Appendix 7 Supplementary Soil and Water Impact Assessment Report

RE: Request for Additional Information – Barina Quarry (DA1-01-2000 Modification 3)

TABLE 1: ADDITIONAL INFORMATION REQUESTED

Figure 1: Receiving Environment Water Quality Monitoring Locations

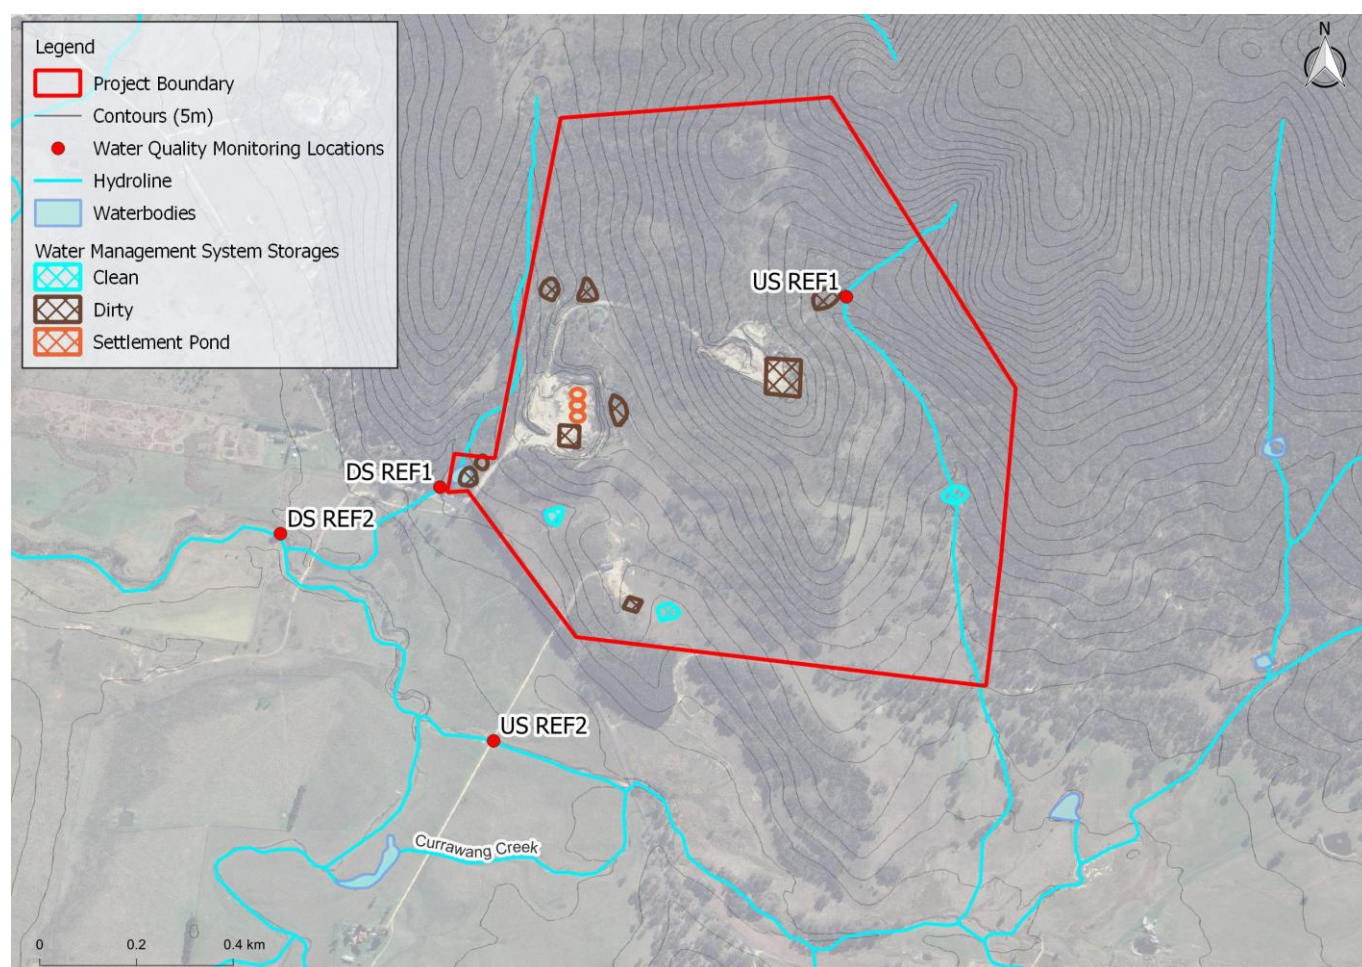
“Classification of water - Section 6.6.3.2 of the Modification Report states that there are three proposed discharge points on proposed Dam 1, Dam 6 and Dam 9 and outlines consideration of NSW Water Quality Objectives (NSW WQO) Australian and New Zealand Guidelines for fresh and Marine Water Quality (ANZG 2018) and appears to adopt 50mg/L as a total suspended solids discharge criteria. The EPA considers that 50mg/L is not an appropriate discharge criterion as any discharge from the site must protect the NSW WQO and environmental values of the receiving waterway. The EPA considers that quarries can be designed and managed to prevent pollution of waterways. Accordingly, the EPA recommends that the premises be managed to prevent a discharge of sediment laden water to the environment by considering a hierarchical approach to onsite water management with procedures clearly captured in a Sediment and erosion control management plan.

The EPA recommends that a detailed water quality objective assessment be undertaken in accordance with the ANZG 2018 prior to consideration of an approved discharge point on the EPL. The EPA does not usually provide licensed water discharge points for a quarry as such developments are expected to be able to operate without polluting the receiving waterway by implementing practical measures to avoid water pollution (for example, utilising sediment basin sizing, reusing water on site, minimising the generation of dirty water).”

The Applicant has been sampling and analysing the surrounding environment water quality quarterly since the start of 2025¹ to establish baseline data that can be used to refine receiving environment WQOs. The Applicant will continue to collect baseline data as part of a detailed WQOs assessment to be undertaken in accordance with the ANZG 2018 for review by the EPA. In the event the Applicant makes application for a licensed discharge point prior to completion of the detailed WQOs assessment, it is proposed that the values presented in Table 2 with

The baseline water quality data for receiving environment monitoring locations captured to date is provided in Table 3. The water quality data can be interpreted as follows:

- Results for pH indicate that the water quality surrounding the site is neutral to slightly alkaline.
- Electrical conductivity at the upstream and downstream reference sites is variable and notably higher than the aquatic ecosystem WQO (30 to 350) for upland rivers.
- The turbidity result is generally lower than the aquatic ecosystem WQO (25 NTU) for upland rivers.
- Results for TSS are variable, ranging between <2 mg/L and 48 mg/L.

Figure 2: Pit 2 Void Landform Catchment

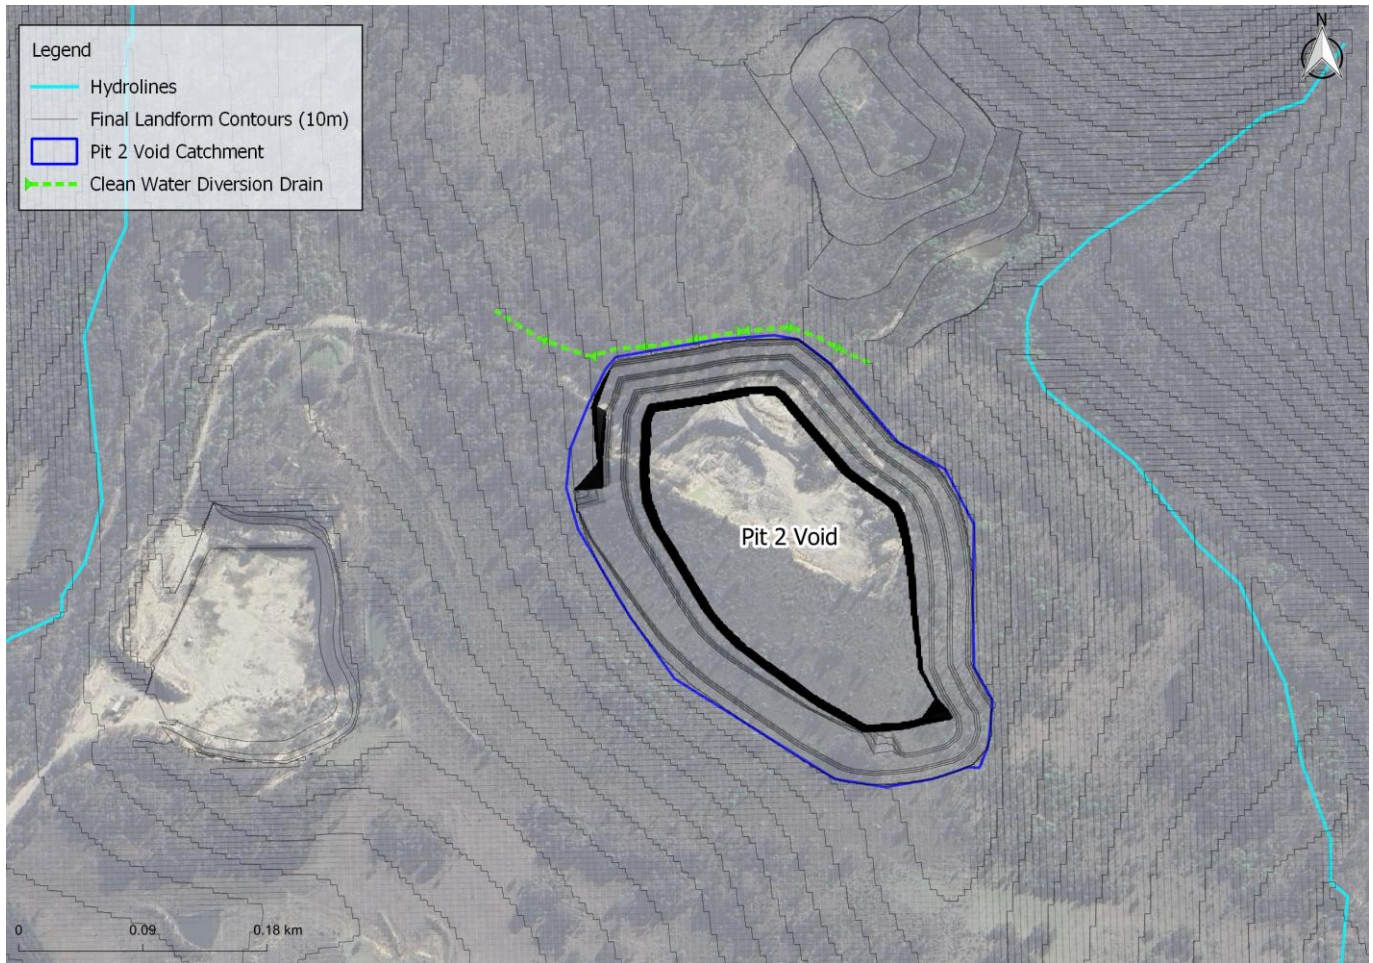
“Provide clarification of the potential for a pit lake to develop in Pit 2 void. Whilst groundwater is not predicted to be intercepted, the surface water assessment does not provide enough information on the surface water flows. In particular, whether water management infrastructure such as diversion drains are required in the final landform to prevent inundation (both short and long term) of the Pit 2 void and how this would impact the proposed final land use of grazing.”

The Pit 2 void (the void) is located on top of a ridgeline (refer to Figure 2). The existing grade of the surrounding landform will be maintained so that there will be minimal external catchment reporting to the void. Clean water drains may be required to divert clean water runoff from the north away from the void. Any clean water drains would be appropriately sized and lined to prevent scour. The only rainfall runoff inflows to the void will be the result of incident rainfall on the void itself. Groundwater inflows are not anticipated as the maximum proposed extraction depth is above the groundwater table. The void is estimated (based on the preliminary void design) to have a capacity of around 2.3 GL at the end of the quarry life.

To assess the potential for a pit lake to form in the void, the water balance model (WBM) for the Project was updated to incorporate the void topography as a water storage with no dewatering. The WBM was simulated for 134 realisations using the historic climate dataset to assess the potential for a pit lake to develop under different climate conditions. The WBM was simulated for a 100-year period. The maximum volume and level results for the 100 year forecast period are presented in Figure 3 and Figure 4. Smaller scale results for the first 15 years of the 100 year forecast period are also presented in Figure 5 and Figure 6.

- The volume of water in the void is likely to fluctuate seasonally. The modelled inventory increases in winter when evaporative losses are lower and decreases in summer when evaporation exceeds rainfall.
- For the median result the inventory stored in the void fluctuates between being empty and up to approximately 7.9 ML. At 7.9 ML, the depth of water is around 0.2 m.
- For the maximum result (indicative of wet conditions), the maximum inventory stored in the void is around 38.7 ML. At 38.7 ML, the depth of water is around 0.8 m.
- For the minimum result (indicative of dry conditions), the void remains empty for the forecast period.

The results show that there is potential for a shallow pit lake to form in wetter periods and remain empty during dry periods. During median climate conditions there is potential for intermittent wetting and drying in the void to occur.
